**Remarks/Arguments**

**In the Drawings:**

FIG. 4

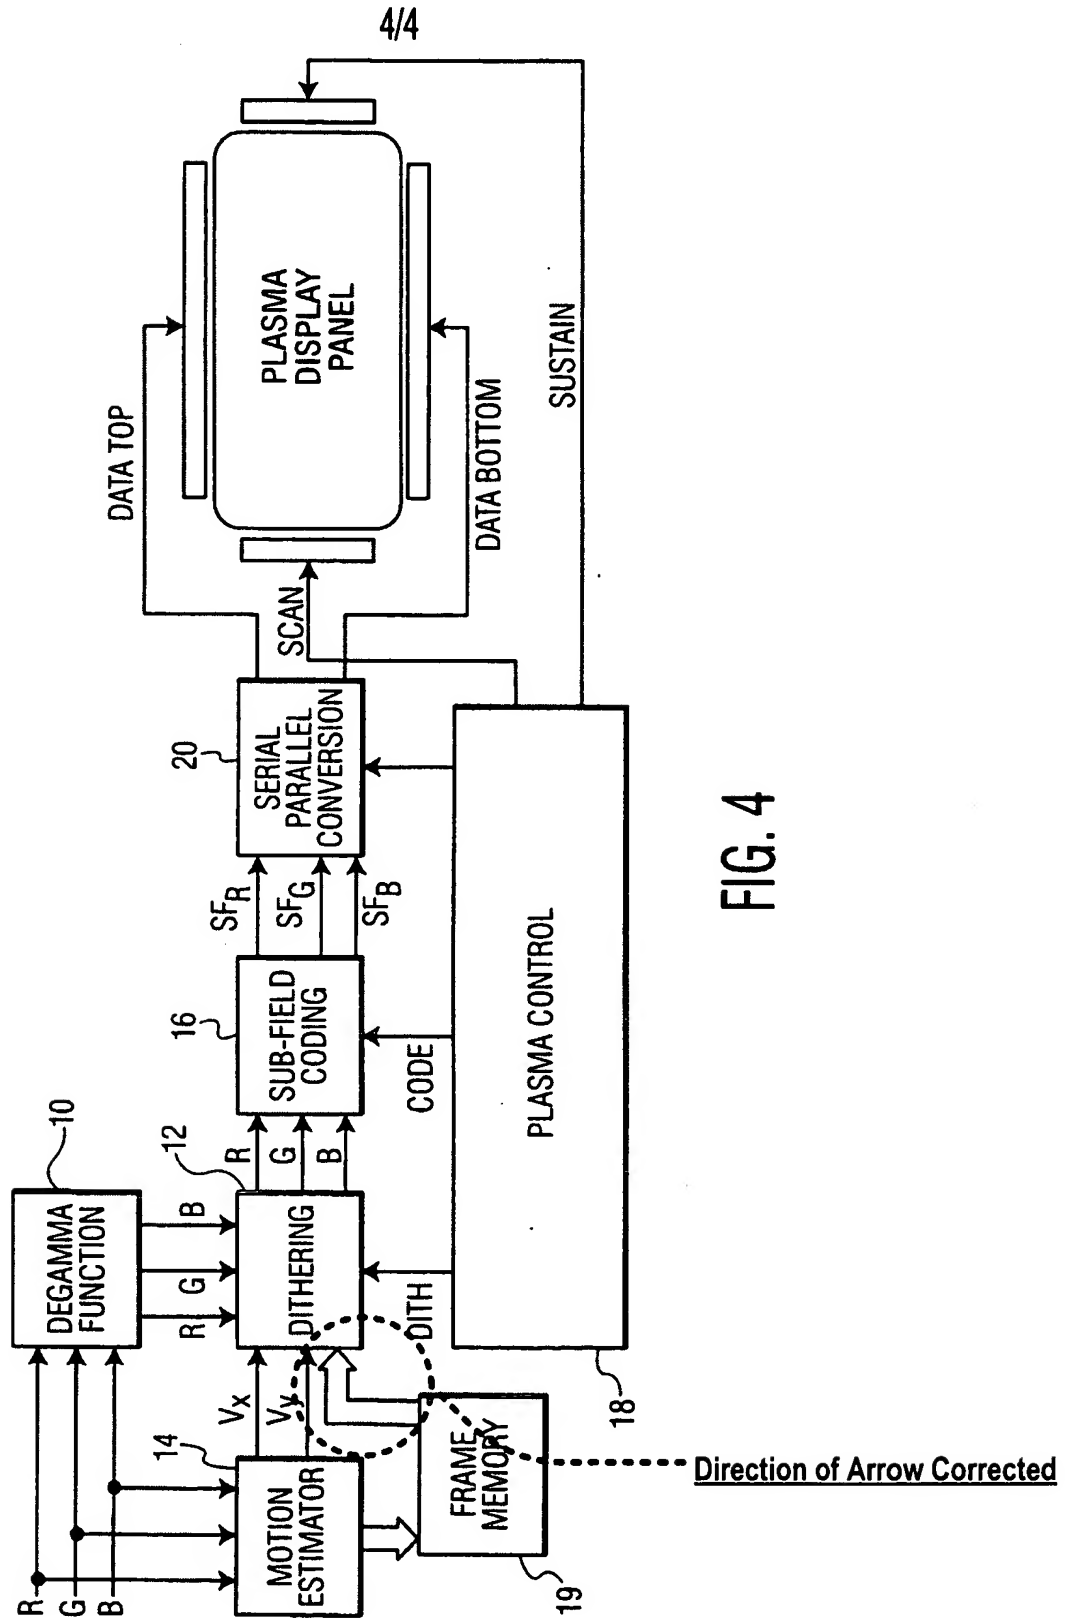
The drawings stand objected to. More particularly, Fig. 4 stands objected to because the specification fails to disclose the item number of the frame memory. Applicant has amended the paragraph beginning on line 8 of page 12, and ending on line 16 of page 12, to refer to frame memory 19. Accordingly, Applicant respectfully requests reconsideration and removal of this objection.

Figure 4 has been amended herein to show frame memory 19 may be used at the dithering block 19 level, as is explicitly stated on page 12 of the specification, in the paragraph beginning in line 8 and ending in line 16. Accordingly, Applicant submits no new matter has been added.

The attached sheet of Drawings includes changes to Figure 4. The attached sheet replaces the original sheet containing Figure 4. The direction of the arrow between frame memory 19 and dithering block 12 has been corrected to point towards dithering block 12.
